NEW YORK STATE DEPARTMENT OF ENVIRONMENTAL CONSERVATION

Re: Notice of Incomplete Application: DEC ID# 8-3422-00003/00001
Eagle Harbor Sand and Gravel Pit (Mine ID #80171)
Town of Barre, Orleans County

RE: Notice of Incomplete Application: DEC ID# 8-3422-00003/00001
Eagle Harbor Sand and Gravel Pit (Mine ID #80171)
Town of Barre, Orleans County

Tributaries to Oak Orchard Creek (ONT-138)
dark blue = Class A
light blue = Class C

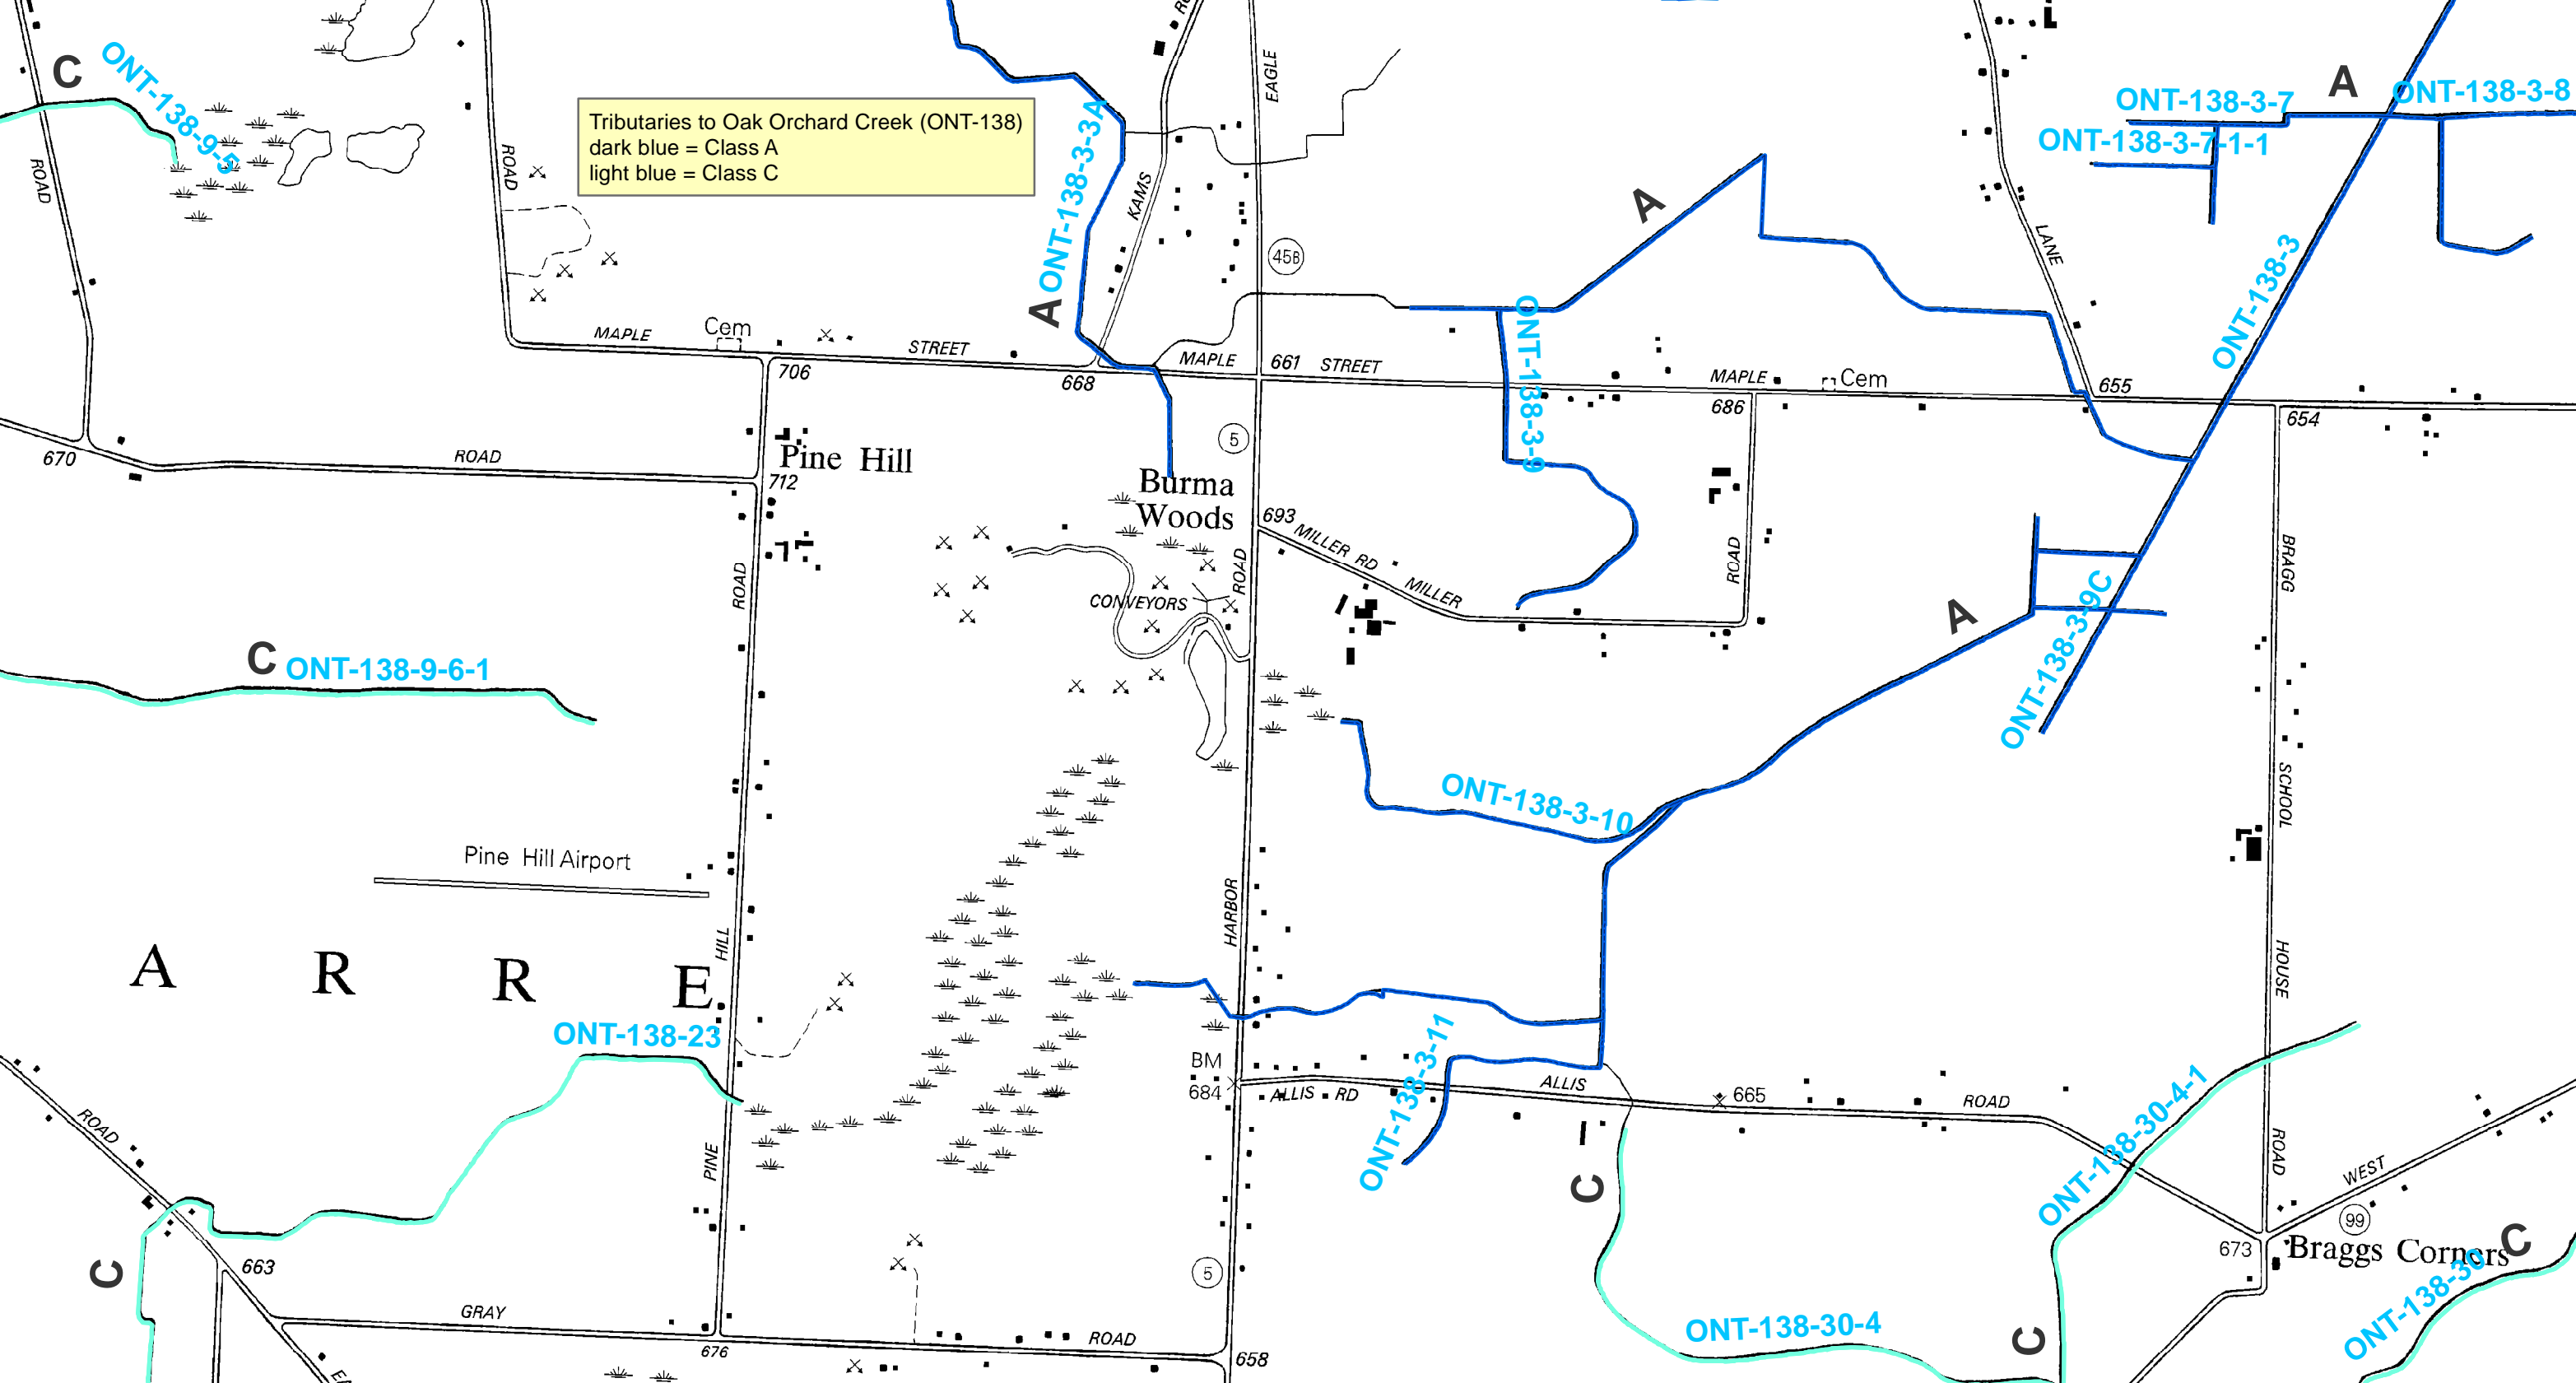
- Our Bureau of Ecosystem Health has provided the attached soils and stream maps to distinguish the streams and headwaters wetlands we discussed.
- Based on the preliminary pump test results, a Water Withdrawal permit application is anticipated to be required. Information on this permitting program and the requirements can be found at: <https://www.dec.ny.gov/lands/55509.html>. Please submit a water withdrawal application once the pump test is complete.

- Our Bureau of Ecosystem Health has provided the attached soils and stream maps to distinguish the streams and headwaters wetlands we discussed.

The requested features were factored into the revised assessment.
